Certificate of Appropriateness 112 S. Hancock Street

April 3, 2023

Proposed Work

Proposed West Elevation

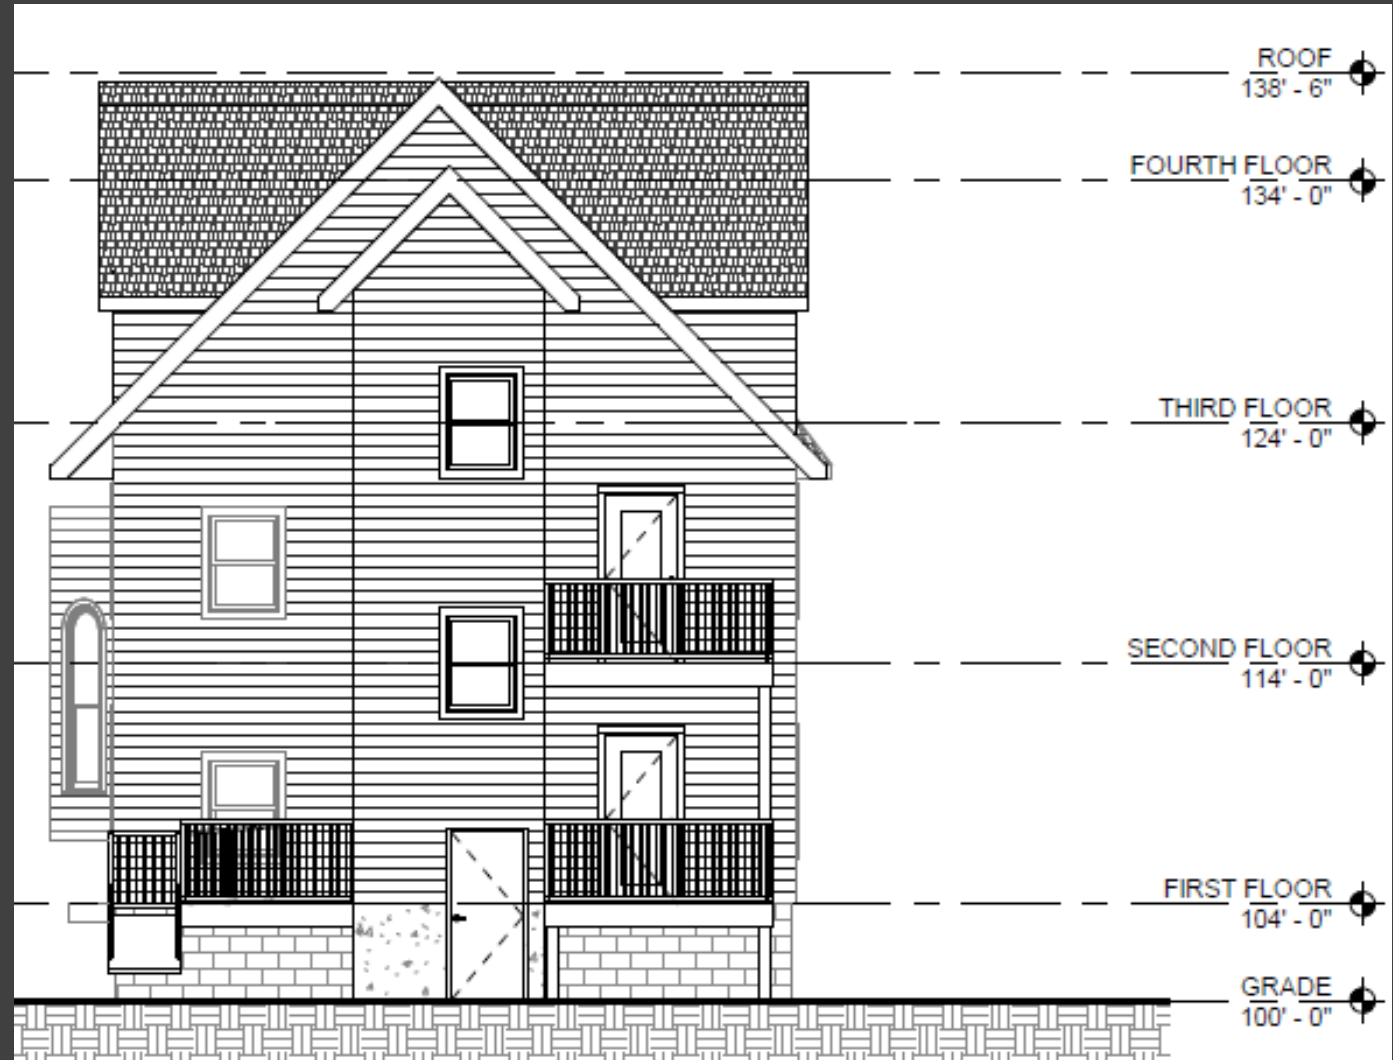
1. Submit updated plans that remove the shed-roof dormers from the design.
2. Final siding and trim specifications be approved administratively by staff. Siding and trim will need to replicate the appearance of the historic wood siding, not the current nonhistoric vinyl siding.
3. Final window specifications be approved by staff. All components will replicate the appearance of wood windows, with no wrapping of the of the window opening.
4. Final door, railing, porch, deck, and roofing materials specifications be approved administratively by staff.
5. Any exterior lighting or mechanicals proposed as part of this project scope will need a Certificate of Appropriateness.
